PLANNING, ZONING, & BUILDING DEPARTMENT
PZ&B Staff Memorandum: Landmarks Preservation Commission

SUBJECT: ZON-24-028 (COA-24-007) 124 VIA BETHESDA (COMBO)

MEETING: FEBRUARY 21, 2024, LPC
MARCH 13, 2024, TC

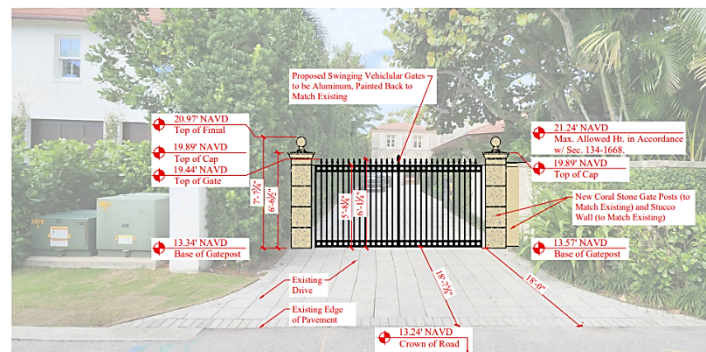
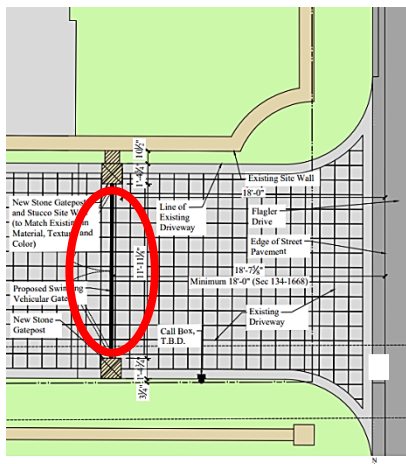
- The application is for the installation of two (2) sliding vehicular gates with a height of approximately 7'-8 $\frac{1}{4}$ " (at the property's north motor court):

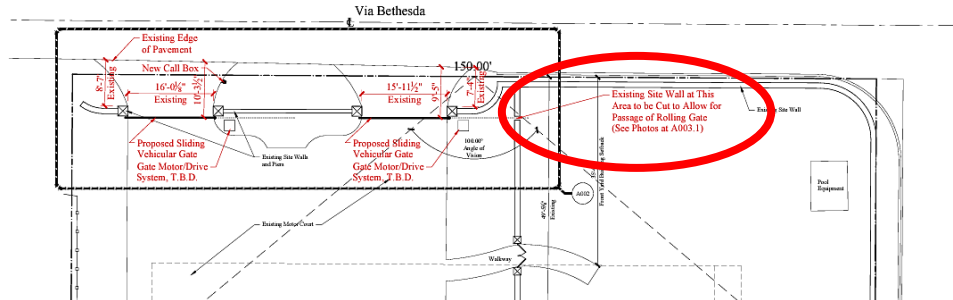
- The application also proposes the installation of one (1) pair of in-swinging vehicular gates at a maximum height of 6'-1 $\frac{1}{4}$ ", gateposts with a height of 7'-7 $\frac{3}{8}$ " (top of finial), and a stucco wall at the property's east driveway:

driveway space on the north side to install two (2) sliding vehicular gates with an approximately 9'-5" (east north gate) and 10'-3 1/2" (west north gate) setback from the edge of pavement of Via Bethesda in lieu of the 18'-0" minimum required for vehicle queuing depth between the driveway gate and edge of roadway.
